STERLING RANCH EAST FILING 5 PRELIMINARY PLAN

LETTER OF INTENT

AUGUST 2023

File #:

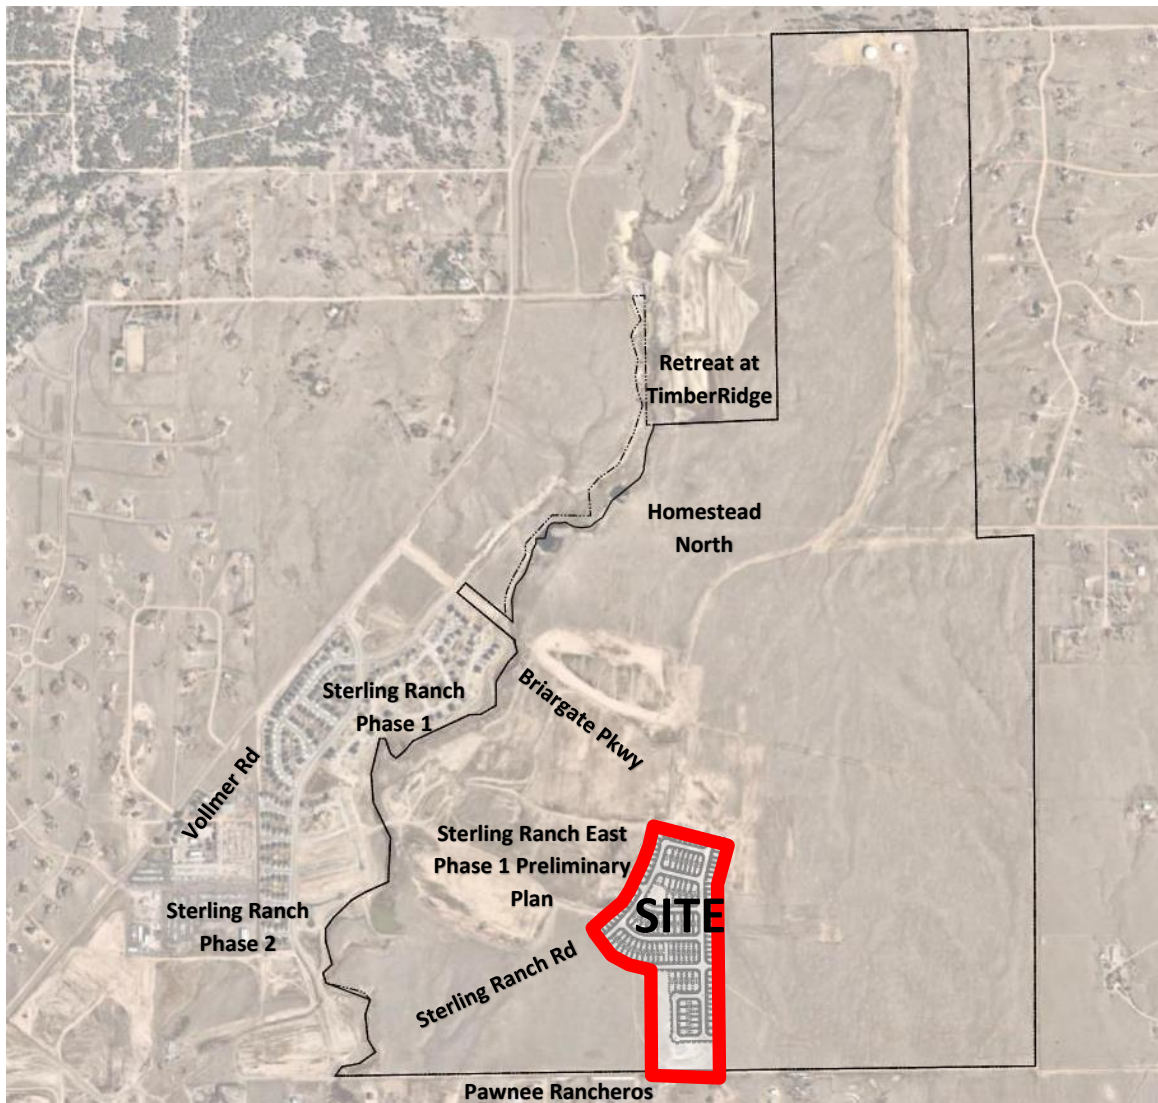
Has the RR0.5 land already been used in another density
calculation? It can only be used once- is that why the prelim
is larger than the rezone? address please.
